UNITED STATES PATENT AND TRADEMARK OFFICE

APPLICATION NO.	FILING DATE	FIRST NAMED INVENTOR	ATTORNEY DOCKET NO.	CONFIRMATION NO.
10/661,287	09/12/2003	Feng Chen	TI-35766 (032350:B524)	7460
23494	7590	07/26/2005	EXAMINER	
TEXAS INSTRUMENTS INCORPORATED P O BOX 655474, M/S 3999 DALLAS, TX 75265			WILLIAMS, HOWARD L	
			ART UNIT	PAPER NUMBER

Office Action Summary	Application No. 10/661,287	Applicant(s) CHEN, FENG	
	Examiner Howard L. Williams	Art Unit 2819

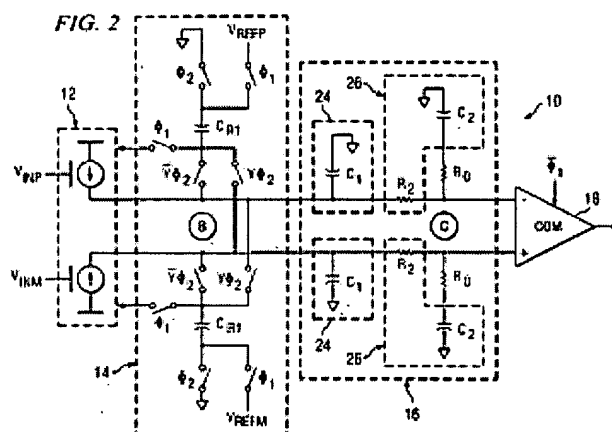
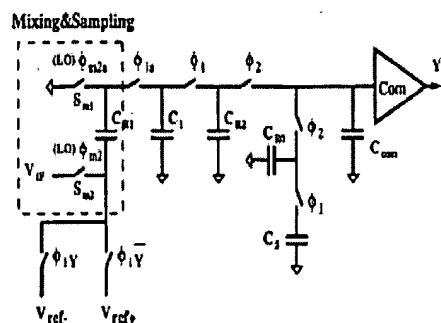
Benabes does not disclose the filters as active as the remarks imply. From the introduction one would not read the use of any amplifier associated with a filter. Benabe's goal it seems is to use passive filters. Benabes shows in his figure 2 a switch and hold element (as a box) which can be

readily implemented with a capacitor alone. Particularly where the goal is passive filters. Turning to the Chen article, it too shows passive discrete time feedback and a comparison with figure of the present application seems useful

While the Chen article uses a single line drawing and figure 2 shows differential the feedback in both appears quite passive and that even the reference characters for the elements are labeled similarly.
